37/3-96GG 7307 Takoma Avenue
(Takoma Park Historic District)

HISTORIC PRESERVATION COMMISSION STAFF REPORT

Address: 7307 Takoma Avenue, Takoma Park

PROPOSAL: Tower siding restoration, restore and enlarge porch. RECOMMEND: Approve

4 PLAN & ELEVATION @ FRONT DOOR
1/2" = 1'-0"

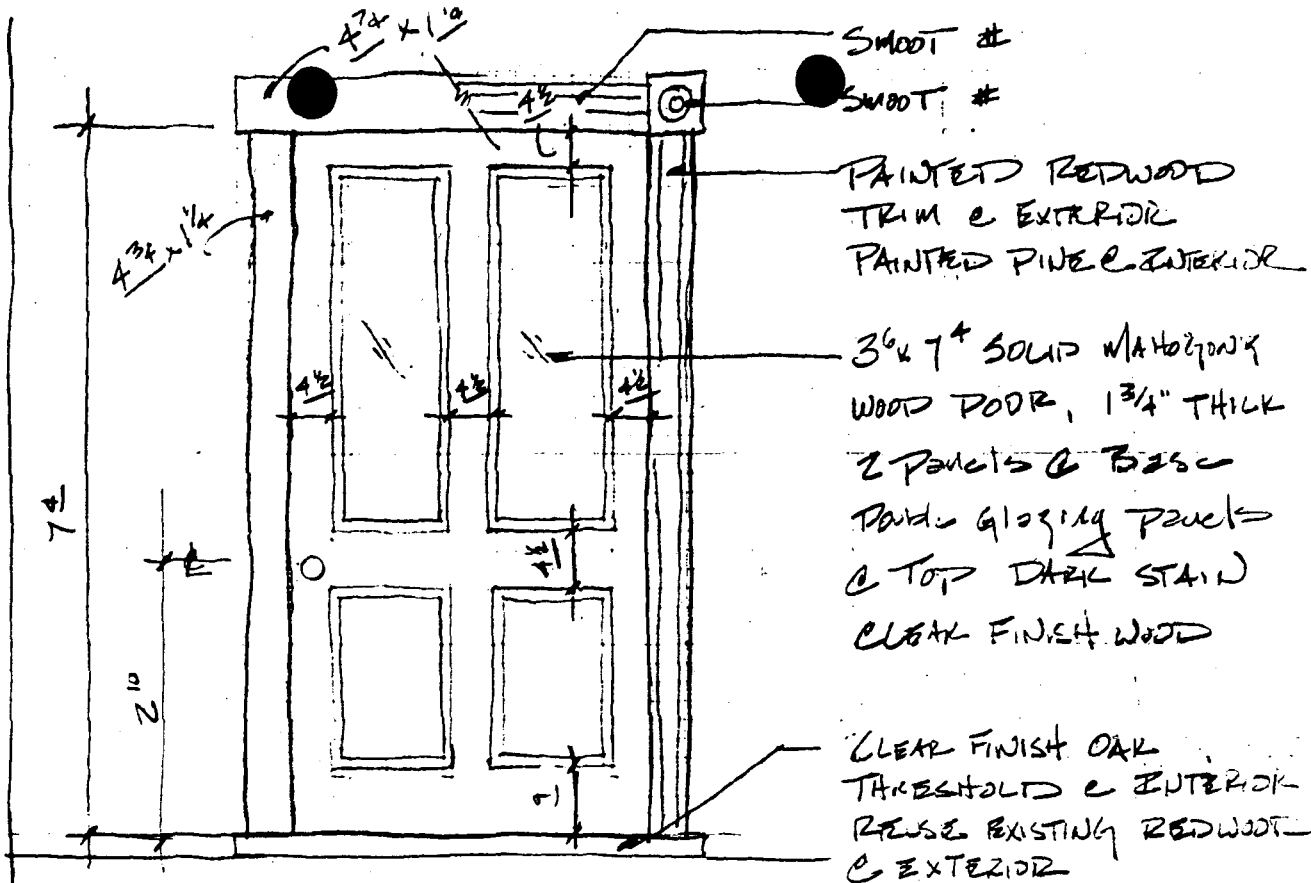
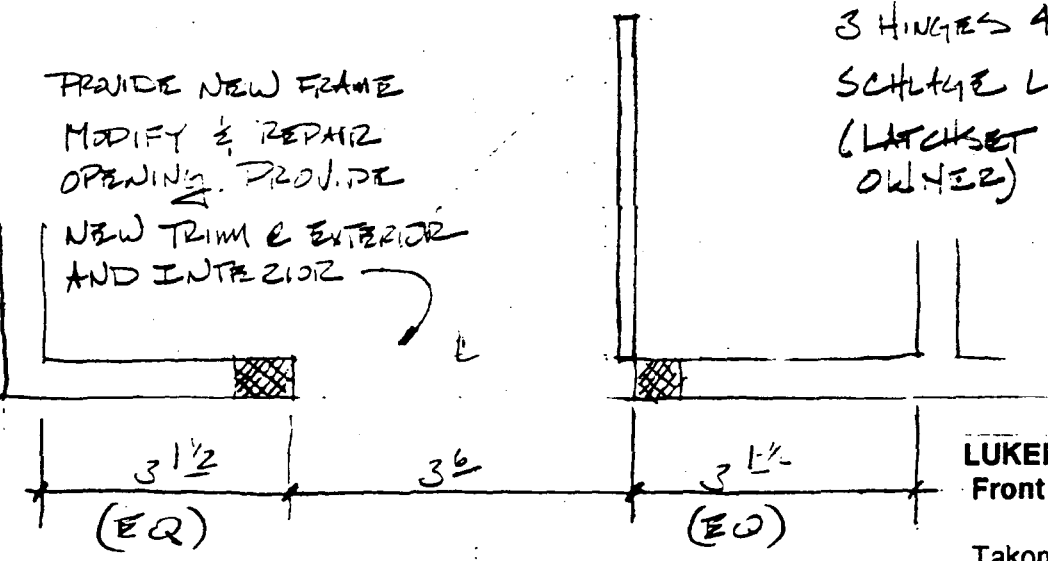
Finally, staff commends the applicant on the extensive repair work which is included in the proposal, including the replacement of the damaged front door with a mahogany and glass door, although leaded and /or stained glass should not be used.

And with the condition that no leaded or stained glass be used in the front door panels.
